**INTRA-DEPARTMENTAL REQUEST FOR INFORMATION/ADVICE REGARDING
A POTENTIAL REFERRAL UNDER SECTION 38A(1) OF THE ENVIRONMENTAL
PROTECTION ACT 1986**

PROPOSAL: KEMERTON TO BUNBURY RAIL ALIGNMENT

KEMERTON BUNBURY RAIL ALIGNMENT
MINIMISING LOSS OF THREATENED ECOLOGICAL COMMUNITIES

Minimising Loss of Threatened
Ecological Communities

THREATENED ECOLOGICAL COMMUNITY
SCP TYPE 3c - OCCURRENCE 7

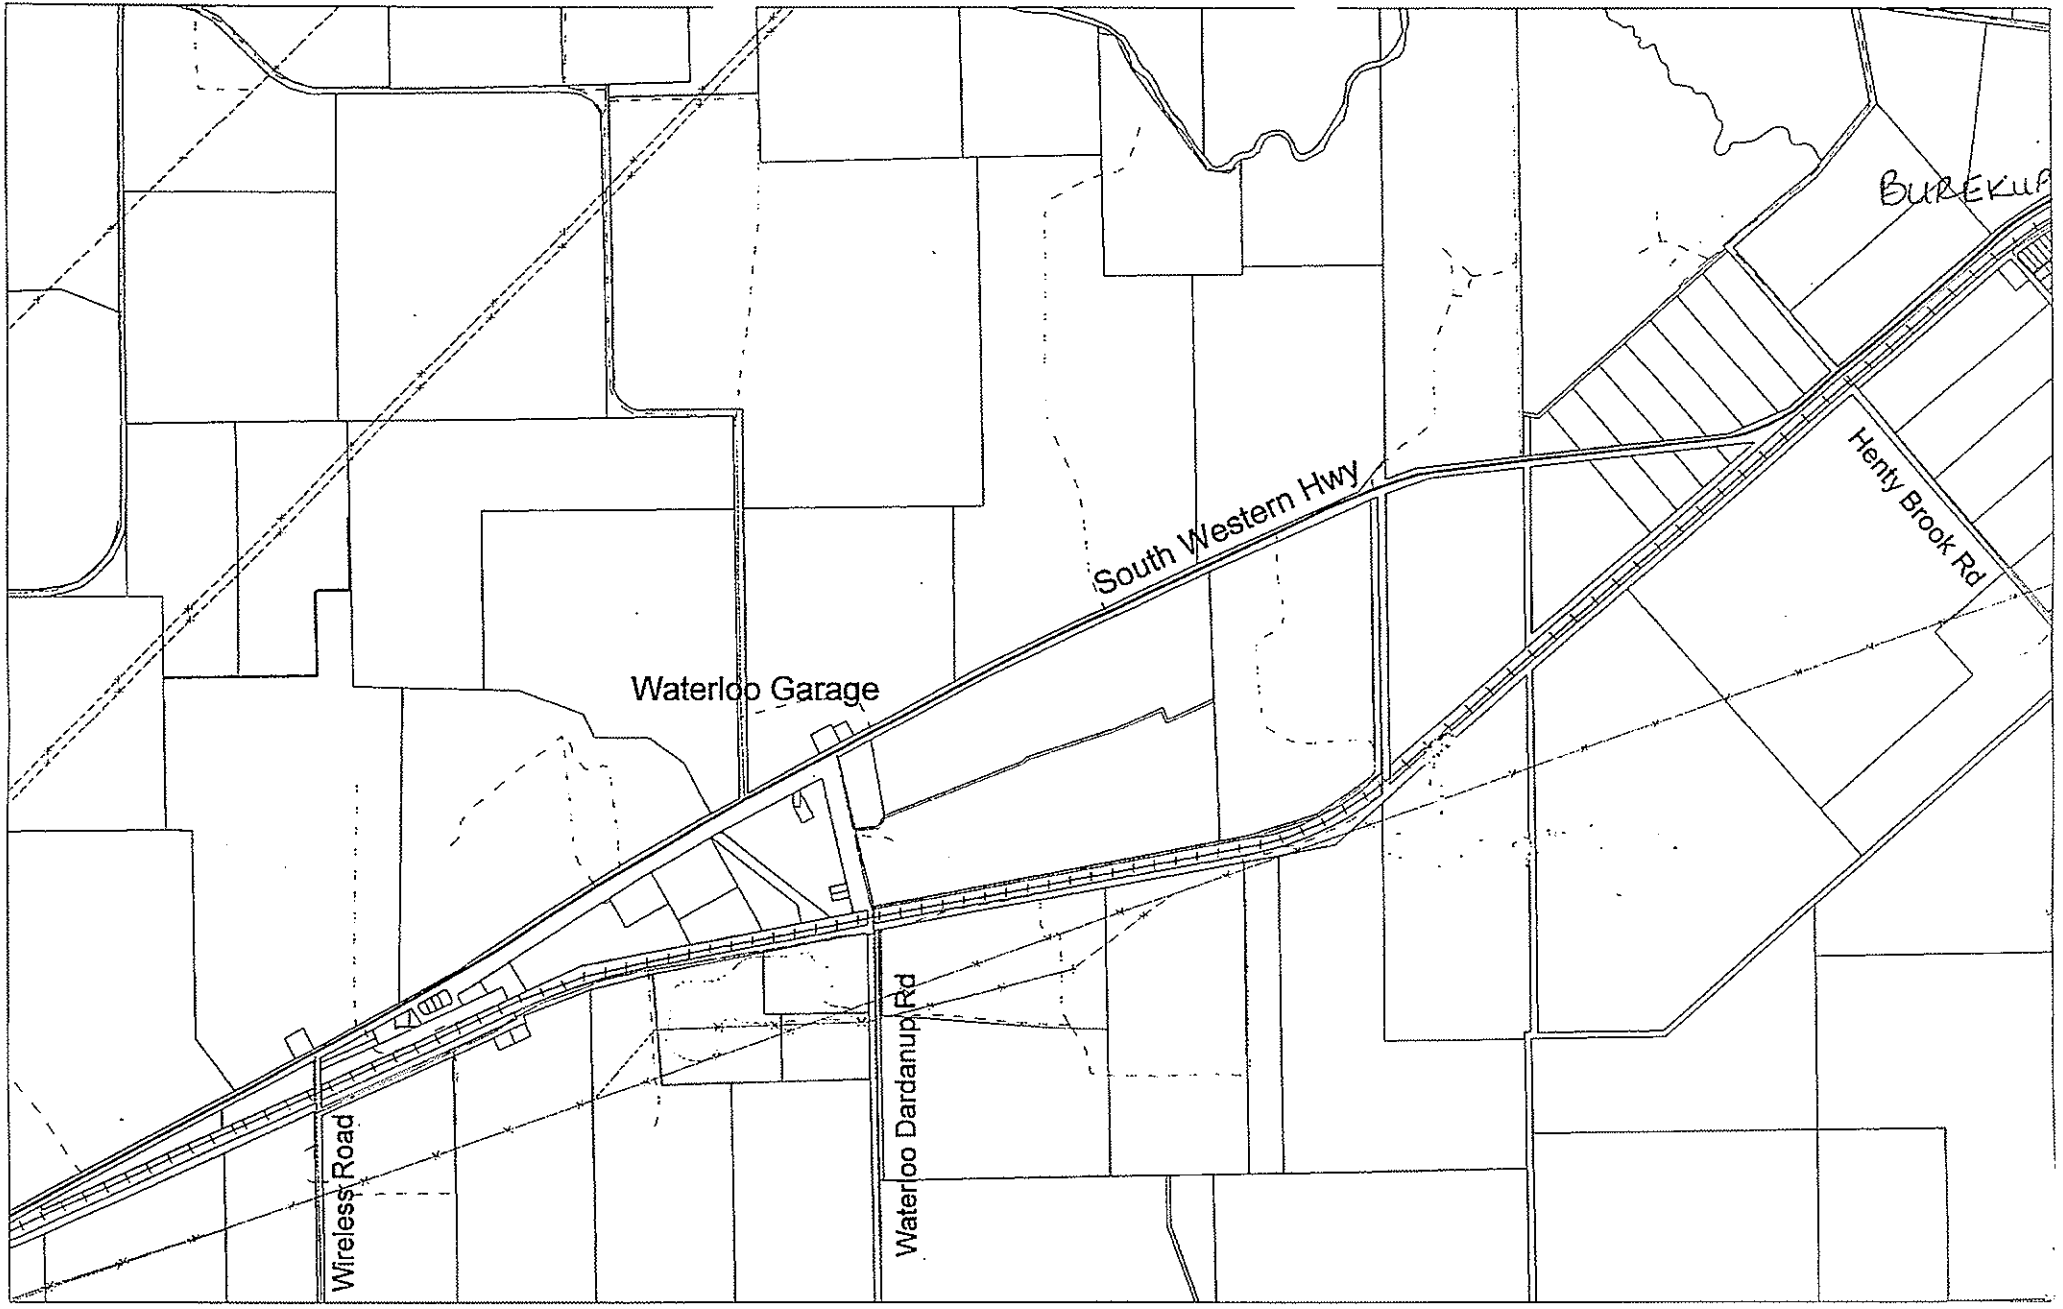
The consultants report correctly identified the presence of plant communities that are on CALM's threatened community database along the proposed rail alignment. In particular, the section of the alignment that occurs between Waterloo-Dardanup Rd and Burekup contains a mosaic of community types 'Eucalyptus calophylla - Xanthorrhoea preissii woodlands and shrublands' (Gibson *et al.* 1994 community type 3c) 'herb rich shrublands in clay pans' (Gibson *et al.* 1994 community type 8) and 'dense shrublands on clay flats' (Gibson *et al.* 1994 community type 9). Type 3c is Critically Endangered, and types 8 and 9 are listed as Vulnerable by CALM. Community 3c is also listed by the Commonwealth as Endangered under the EPBC Act.

Following examination of data held in the consultants report, and other existing knowledge of areas outside of Waterloo-Dardanup Rd to Burekup, it was considered that other portions of the proposed alignment - north of Burekup and south of the Waterloo reserve areas (see map 1 - Waterloo reserve areas contain community type 3c, and need to be avoided) and extending to Bunbury, would not contain significant areas of the above mentioned threatened communities.

Parts of the area between Waterloo-Dardanup Rd and Burekup (see map 2) are disturbed, and weed invasion has occurred. However, the components and general character of the plant communities are maintained, and regeneration is of a standard that the area can be considered to contain occurrences of Threatened Ecological Communities (TECs), and as regionally significant. There are few other known occurrences of type 3c TEC, in particular and total area is very limited, and the protection and proper management of this site is considered to be of significant value.

Further information would allow assessment of whether the proposed rail alignment could be placed without significant disturbance of the conservation values, in particular, TECs and rare flora. For vegetation along the proposed alignment between Waterloo Rd and Burrekup, assessment of the relative conservation value of portions of the area should be undertaken, with regard for the following:

- The community type present, and the category of threat.
- The width of the remnant on either side of the current rail alignment.
- The level of historical disturbance, and the current level of weed infestation.
- The presence of declared rare and priority flora (with due regard to the comparative category of threat. Note: this would require survey in spring, to positively identify flowering individuals and annuals.)

A very accurate map should be produced to differentiate these features. From this, a suitable alignment may be identified that avoids areas of the more threatened TEC, in particular, that are in good condition, and also avoids Declared Rare Flora.
